## **NORTHERN BEACHES INDEPENDENT ASSESSMENT PANEL MEETING**

**WEDNESDAY 9 AUGUST 2017**

| 3.1        | 62 & 85 Hillside Road, Newport - N0371/16.....                                   | 2          |

**Figure 5:** Extracts of the approved plans from Development Consent No. N0274/09 (left) and proposed driveway plans (right) comparing the differences between the approved driveway and proposed modifications.

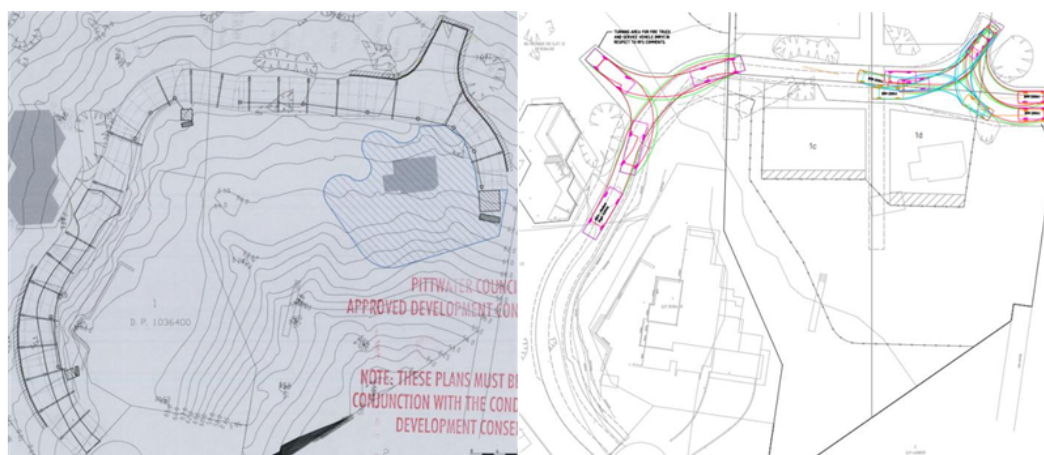
In response to concerns about road safety, the individual actions and movements of drivers and vehicles within public road reserves is not a matter that is capable of being assessed within the scope of the subject application. The driveway crossover's location remains unchanged from that approved by Development Consent No. N0274/09. The addition of new/modified internal turning bays (refer to figure 5) have been designed to permit manoeuvring of vehicles (including Medium Rigid Vehicles (MRVs)) within the subject site, thereby allowing the forward entry/exit of such vehicles without the need to manoeuvre within the cul-de-sac turning head; recommended conditions would also require that:

| Clause  | Numerical Standard   | Numerical Proposal  | T | O | N |
|---|--|---|---|---|---|
| 7.9 Residual lots   |  |   | - | - | - |

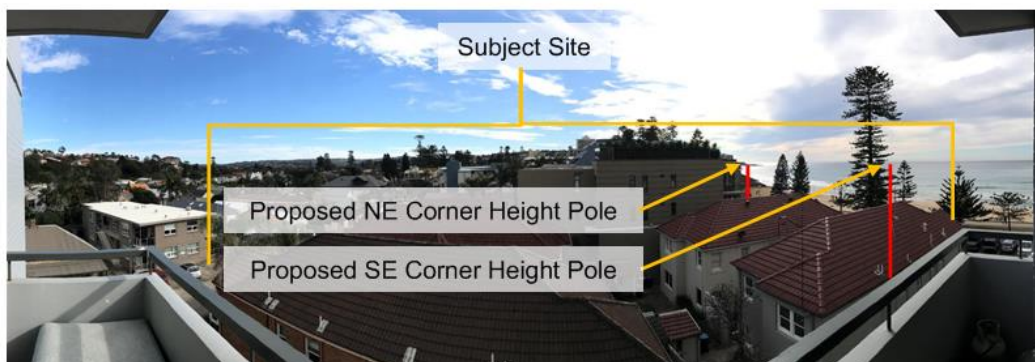
| Clause  | Numerical Standard   | Numerical Proposal  | T | O | N |
|---|--|---|---|---|---|
| 7.10 Essential services   |  |   | Y | Y | N |

**7.4D Detailed assessments of relevant provisions within (PLEP) 2014**

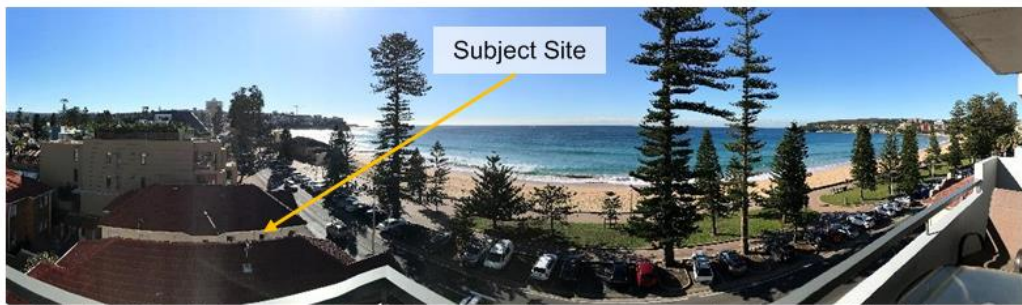
**Planner comments:**
